Certificate of Appropriateness
1245 Spaight Street
November 15, 2021

- Demolish existing front porch
- Construct new front porch

PORCH FRONT ELEVATION
 1/4" = 1'-0"

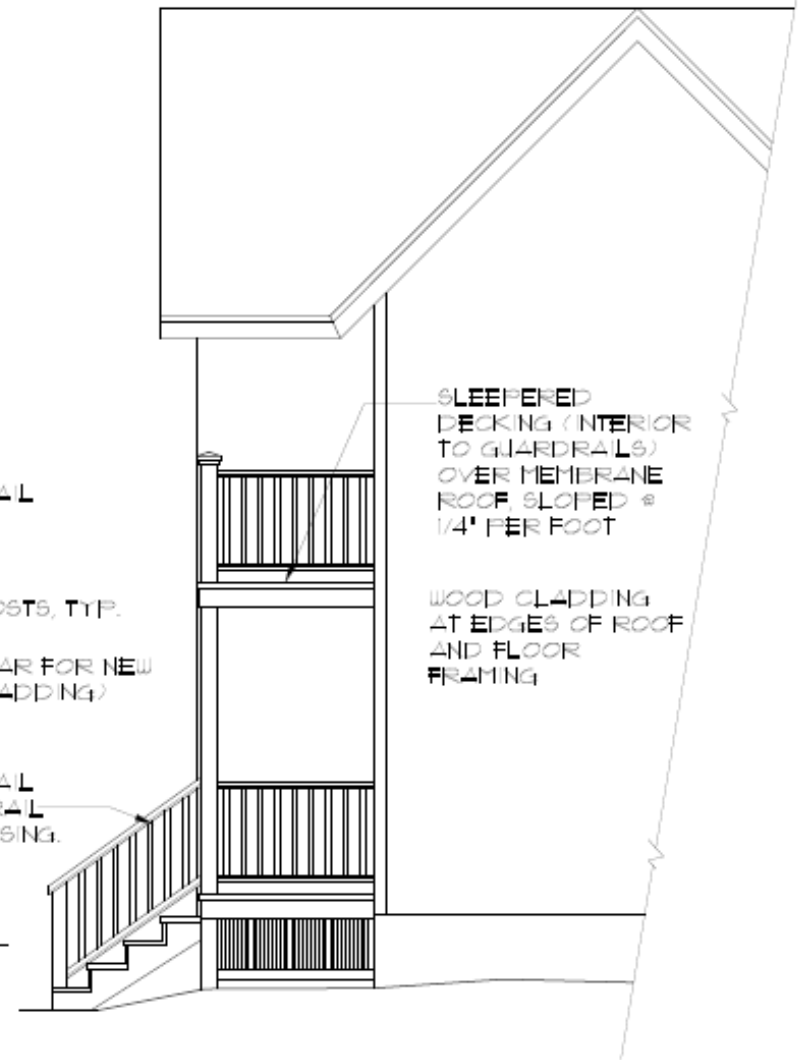
Staff believes that the standards for granting a Certificate of Appropriateness are met and recommends that the Landmarks Commission approve the project as proposed.
